# Shearwater Petrel 2/Perdix/Perdix AI/NERD 2/ Peregrine Firmware Release Notes

## VERSION 97 2023-08-16

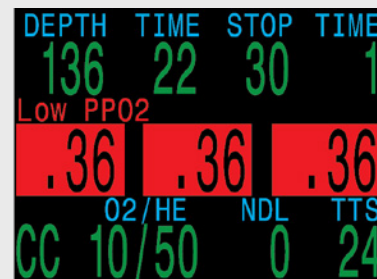
Vibrating alarms have been added.

The vibrations will occur every 10 seconds while a Warning, Error, or Alert message is actively displayed along the bottom row of the display. Once the message is cleared by a button press the vibrations will cease, even if the underlying condition remains. Low and High PPO2 alarms from externally monitored PPO2 (CCR) are an exception to this rule (see below). Vibrations can be completely disabled.

Vibrating alarms have been added whenever an Alert, Warning, or Error is being displayed

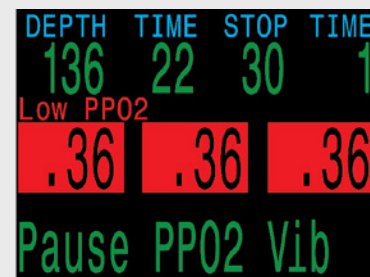
Continuous vibrating alarms for externally monitored (CCR) low and high PPO2 have been added.

Due to the critical importance of PPO2 levels in a closed-circuit rebreather, externally monitored PPO2 alarms will continue to vibrate every 10 seconds, even after the message has been acknowledged, as long as the alarm condition remains.

A “Pause PPO2 Vib.” Menu option will be available while a PPO2 vibrating alarm condition is active. This will pause PPO2 vibrating alarms for five (5) minutes. During this time other warning conditions will still cause vibrations.

When a Low or High external PPO2 alarm exists, the vibrating alarm will continue even after the Warning message has been cleared.

While such vibrations are active, a menu option will be available to Pause PPO2 Vibrations

This will pause vibrations for 5 minutes

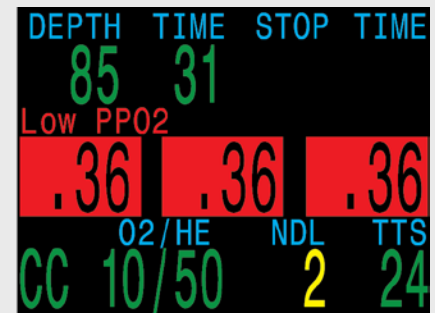
Support for Petrel 3 hardware with a 2.6" AMOLED display.

The default color for the AMOLED display is green. White cannot be chosen as an option for the Main color

The AMOLED on the Petrel 3 features bright vibrant colors and a larger 2.6" size

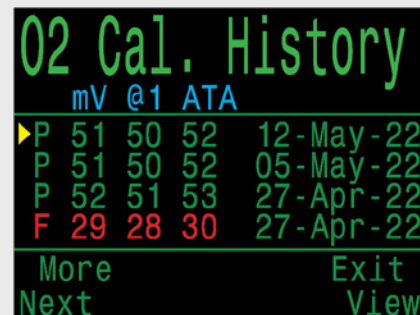
Displays a history of PPO2 calibrations. A log browser shows the date, status, millivolt (mV) levels, and input parameters for all PPO2 calibrations.

A history of PPO2 calibration results can be viewed

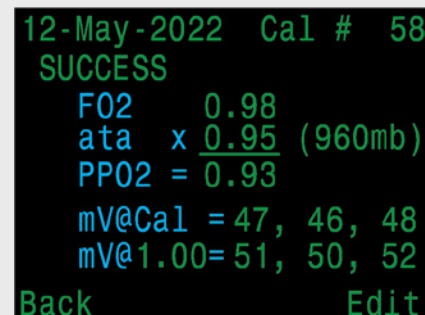
12-May-2022 Cal # 58	
SUCCESS	
F02	0.98
ata x	0.95 (960mb)
PPO2 =	0.93
mV@Cal =	47, 46, 48
mV@1.00=	51, 50, 52
Back	Edit

Details of each calibration can be viewed

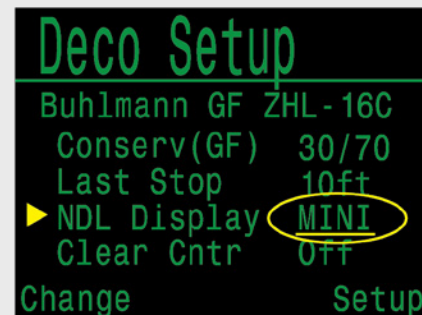
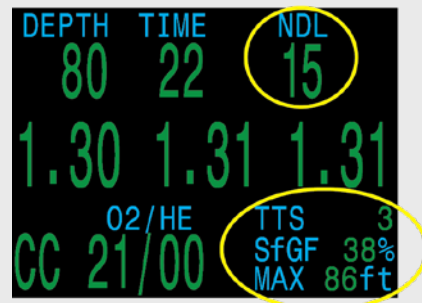
The “NDL Display” setting can be set to “Mini”. The Mini display can be configured to show 2 custom values, in addition to TTS which is fixed. The main display is slightly changed, with NDL moving up to the top right where DECO STOP is normally shown. NDL will show here until deco stops are needed, at which time it will change automatically to show deco stops.

A MINI display be chosen as the NDL Display setting

This option will move NDL up to the DECO STOP area. Once deco stops are needed they will replace the NDL.

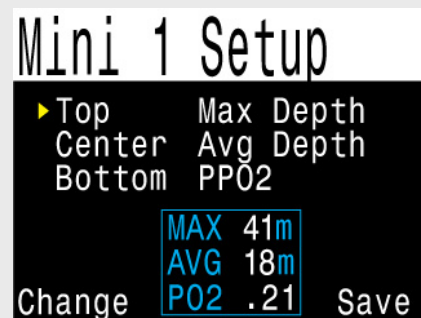
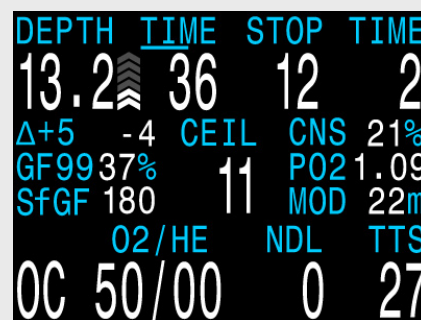
Configurable Mini displays have been added. These allow up to 3 displays to be shown in the area normally used for 1 display, although at a smaller font size.

Two Mini display sets can be configured. The set configurations are separate for the tec modes (OC Tec, CC/BO) and the rec modes (Air, Nitrox, 3 GasNx).

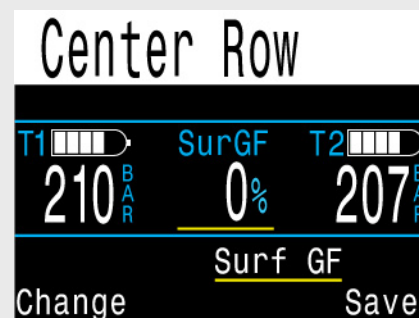
Previews of the tec center row display configuration have been added to make display setup easier.

Also, more options are available in the tec modes center position.

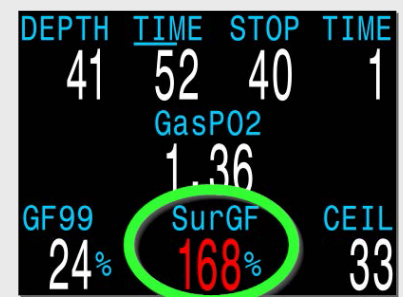
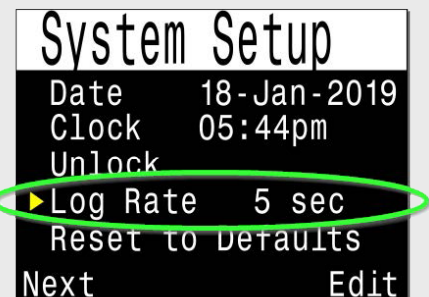
Surface GF display added. This shows the gradient factor if you were to surface immediately. This is different from GF99, which shows your gradient factor at the current depth. Is available:

Surface GF is the gradient factor if you were to instantly ascend to the surface

Log Rate can be set to 2, 5, or 10 seconds

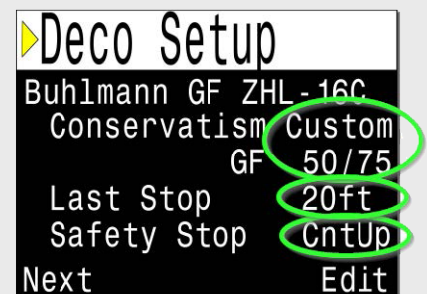
Allows user to select a 20ft/6m last stop depth in OC Rec mode. Previously the last stop was always 10ft/3m in OC Rec mode.

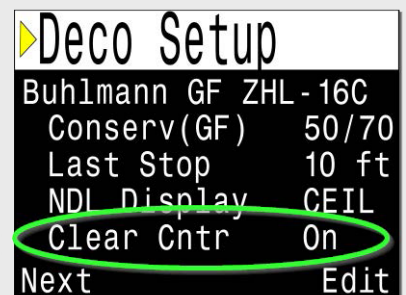
When deco clears this counter begins counting up from 0. It is useful for timing additional padding after the mandatory decompression stops. If the dive did not need deco, then begins upon entering the safety stop zone (i.e. shallower than 20ft / 6m).

The “Clear Counter” counts up once deco is clear

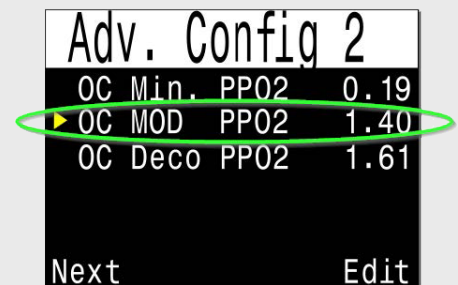
The PPO2 limit options have been changed for OC Tec mode.

The “OC Max PPO2” has now been removed and replaced with a “OC MOD PPO2” setting. The MOD setting only applies to the bottom depth phase. The dive computer automatically switches to using the “OC Deco PPO2” limit when within 2 stops of the next deco stop. The “OC Deco PPO2” limit also sets where predictive deco gas switches occur. Also, if the current gas has greater than or equal to 80% oxygen fraction, then the deco limit is used, as the gas is assumed to be a deco gas.

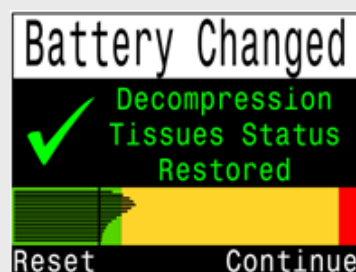
**CHANGE** Compass mark heading menu moved to reduce button presses. Also, the compass can now be viewed while marking. Operation: when viewing compass a left button press brings up an "Exit/Mark" menu. Right press marks compass, Left press exits to main screen. Previously had to navigate to regular menus to mark the compass.

The mark heading command now requires less button presses

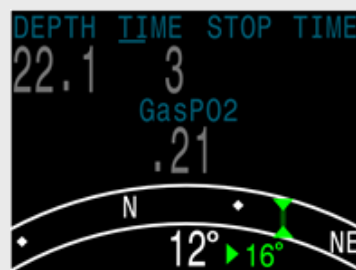
**IMPROVE** When a heading is marked, the display now shows the offset angle between the current heading and the marked heading. This is useful for navigating patterns. For example, a box pattern requires turns at 90° intervals, while a triangle pattern requires turns at 120° intervals.

The offset between current and marked heading is now shown (in this example 16°)

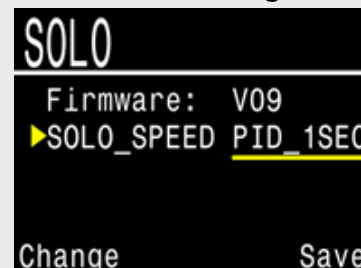
For example, on the SOLO board (solenoid and oxygen controller) the Solenoid Speed setting can be adjusted. Go to “Bus Devices” page on Petrel to access peripheral boards. Settings viewed here are stored on the peripheral device.

On the “Bus Devices” page, choose “View” to see more info and settings

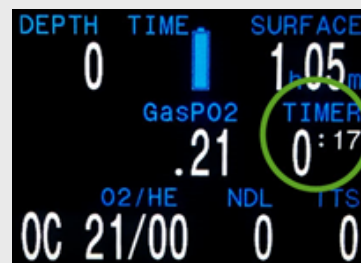
The current compass numerical value (azimuth) is shown on the “Mark Heading” menu.
